REQUEST FOR AMENDMENT TO TECHNICAL SPECIFICATION 3/4.6.3,  
PRIMARY CONTAINMENT ISOLATION VALVES

Attachment 2  
Page 1 of 5

**A. DESCRIPTION OF AMENDMENT REQUEST**

FIGURE 1

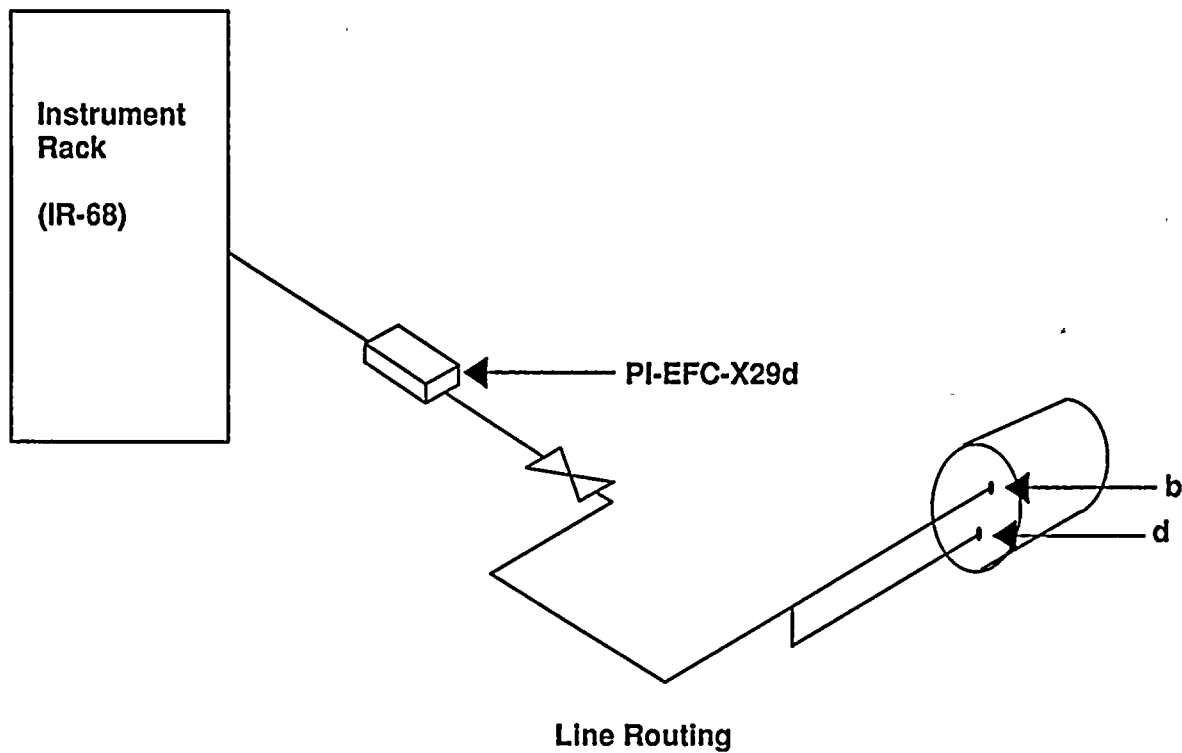
The containment atmosphere instrument lines use a dual tube method of draining condensate from the drywell pressure sensing lines (Figure 1). The bottom tube serves as a trap for condensate drainage to ensure that any condensate from the drywell atmosphere will not block the instrument line and prevent line instrumentation from performing the required sensing function. Standard nomenclature for dual tube configurations identifies excess flow check valves (EFCs or EFCXs) in Technical Specification Table 3.6.3-1 by the instrument line penetration number. However, PI-EFC-X29d is identified by the drain line penetration number rather than the instrument line penetration number. This issue has been previously addressed in Amendment 26 which changed the EPN designation for these excess flow check valves.

Renaming PI-EFC-X29d to PI-EFC-X29b will provide consistency between this excess flow check valve and five other excess flow check valves used on dual tube installations and identified in Technical Specification Table 3.6.3-1. Renaming PI-EFC-X29d to PI-EFC-X29b is an administrative change. This component is correctly identified as PI-EFC-X29b in all plant documentation including Master Equipment List, the process instrumentation drawing, and Technical Specification surveillance procedure. Therefore, the EPN change has no adverse safety impact.

- Rename PI-EFC-X29d to PI-EFC-X29b to conform to plant documentation.
- Rename PI-EFCX-72f and PI-EFCX-73e to PI-V-X72f/1 and PI-V-X73e/1 to reflect the replacement of these excess flow check valves with swing check valves.
